**Cornwall Solar Project
Renewable Energy Approval
Modification Report**

FINAL REPORT

October 16, 2020

CORNWALL SOLAR PROJECT RENEWABLE ENERGY APPROVAL MODIFICATION REPORT

Title
SITE PLAN LAYOUT
NOON SHADING AND 26° INSTALLATION TILT

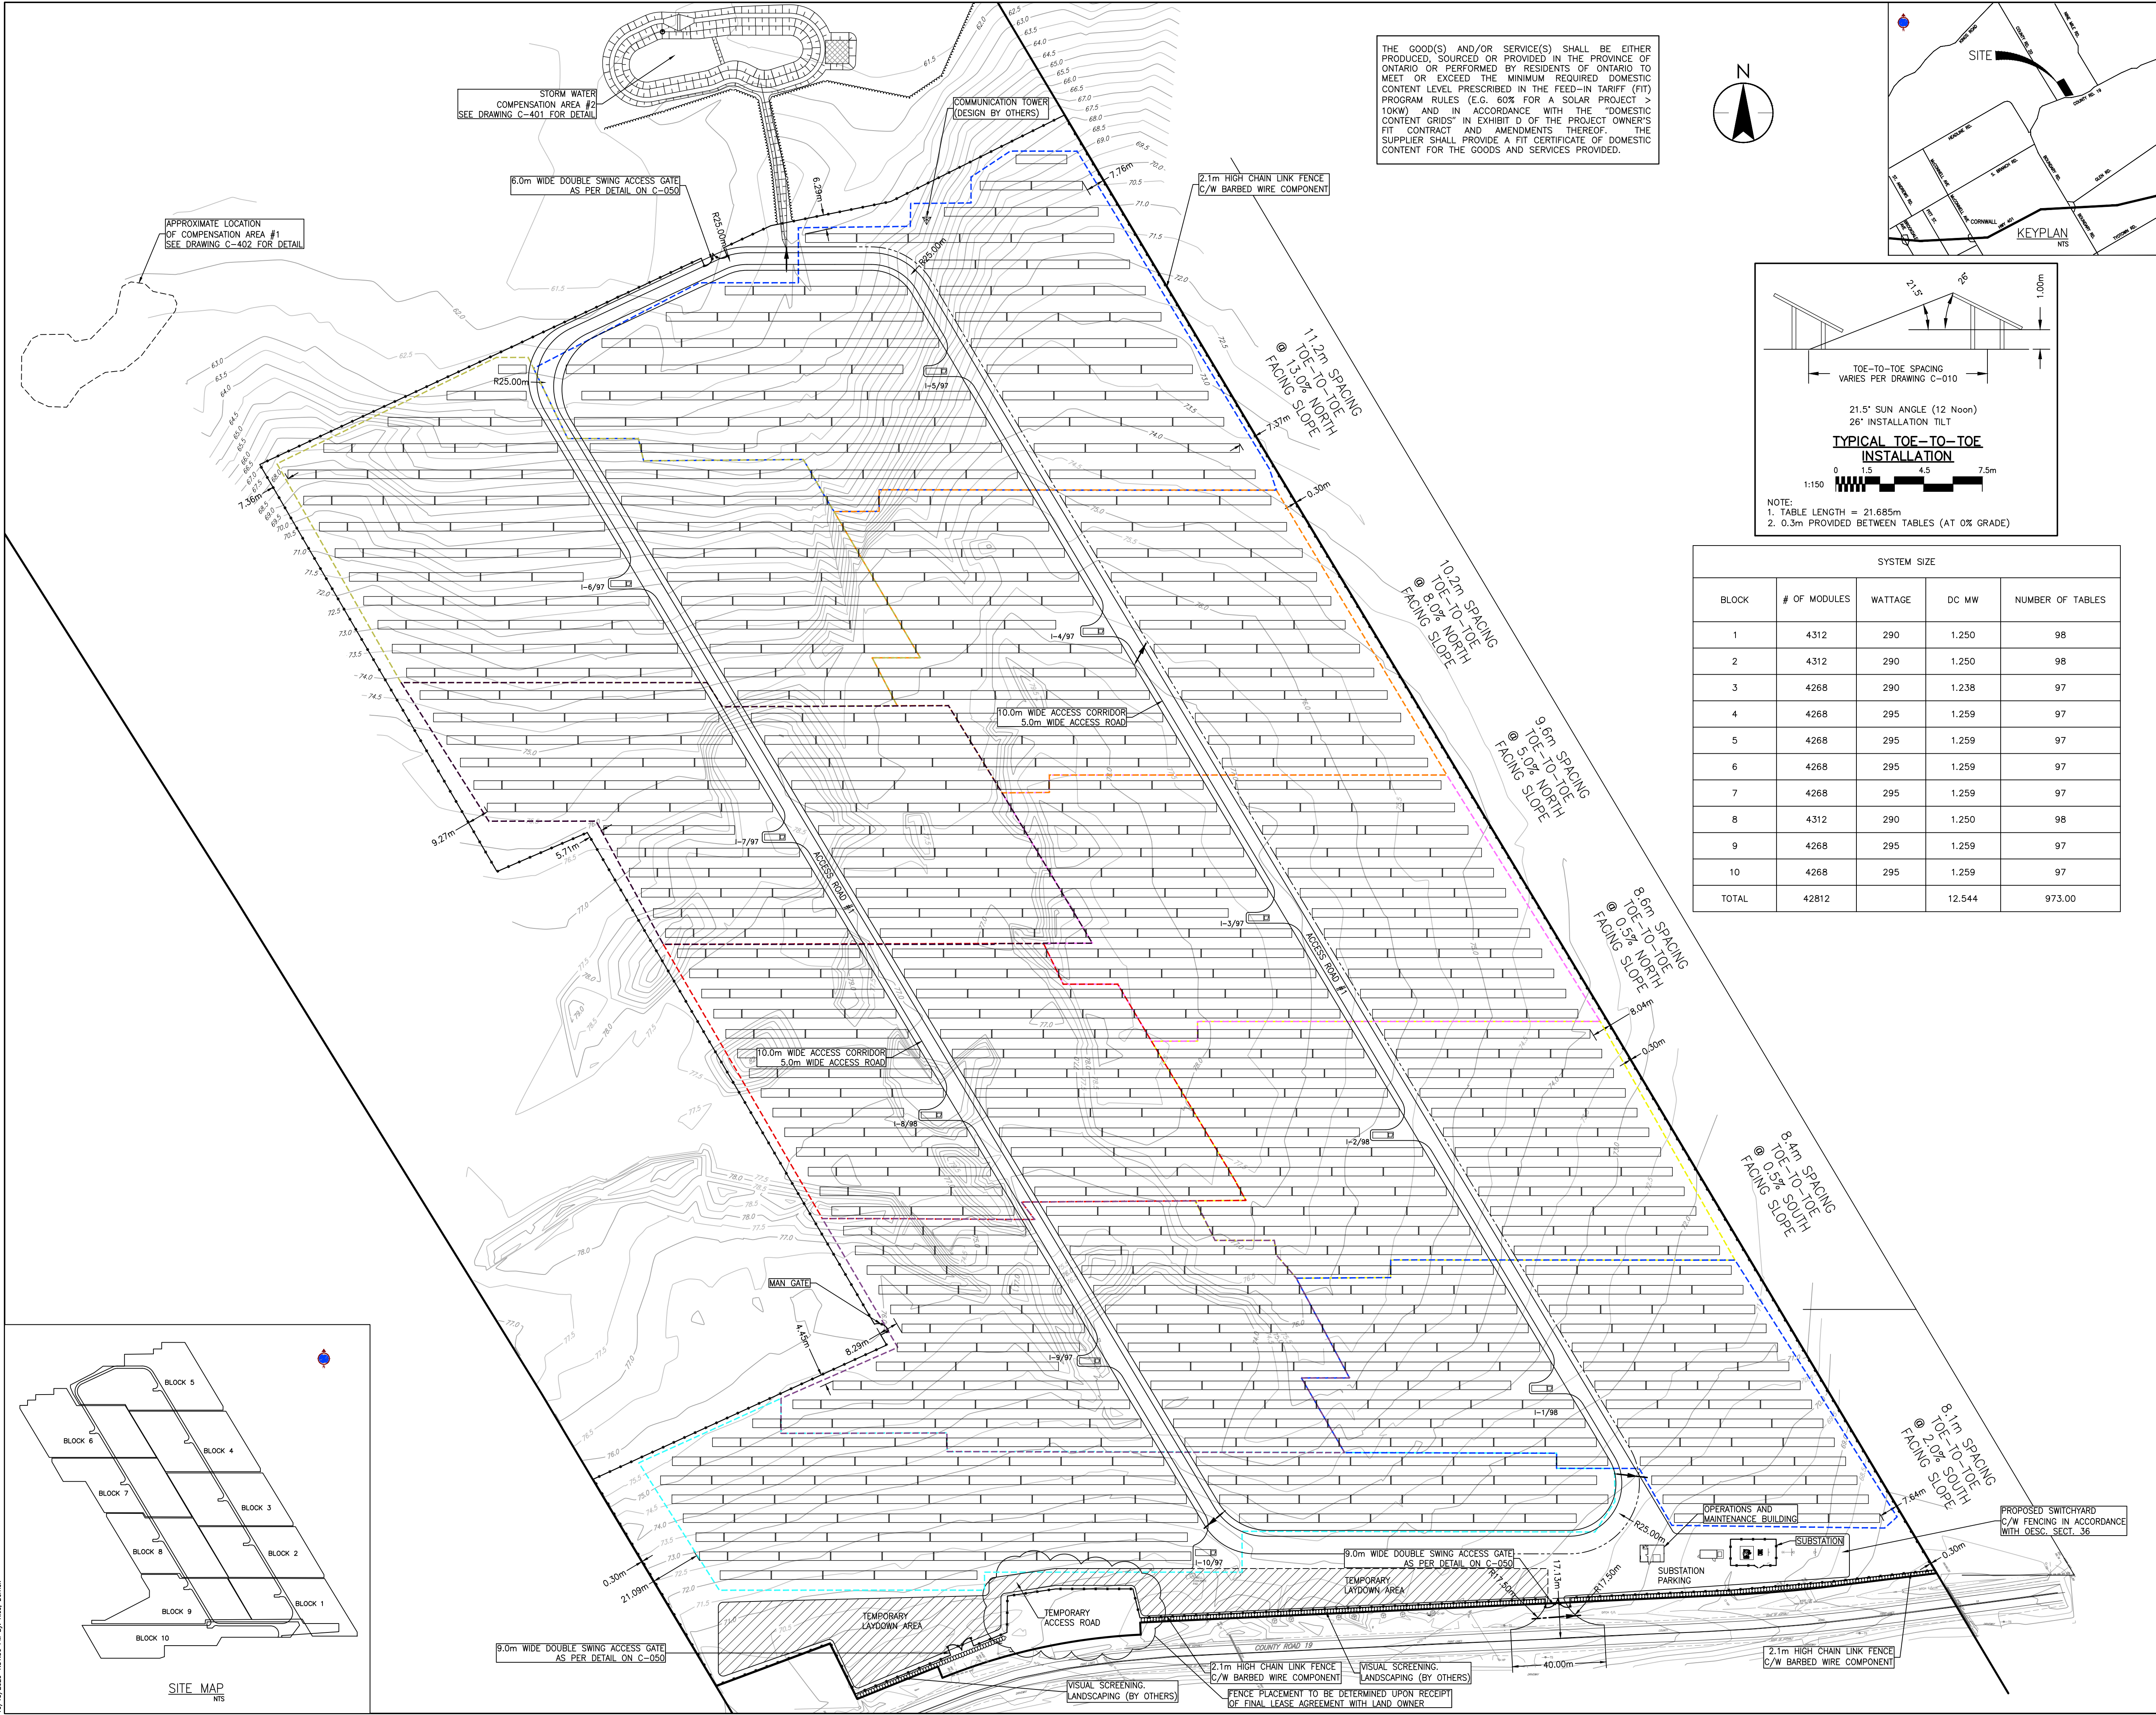
The proposed Project change entails replacing the existing ten intermediate transformers with ten new intermediate transformers in the same locations to address an existing maintenance issue. The proposed replacement transformers will be installed on concrete slab-on-grade, which will not be replaced. The facility's total maximum name plate capacity of 10 megawatt shall remain unchanged.

The proposed Project change entails replacing the existing ten intermediate transformers with ten new intermediate transformers in the same location to address an existing maintenance issue. The proposed replacement transformers will be installed on concrete slab-on-grade, which will not be replaced. The facility's total maximum name plate capacity of 10 megawatt shall remain unchanged.

The proposed layout and placement of transformers is provided in **Appendix A**.
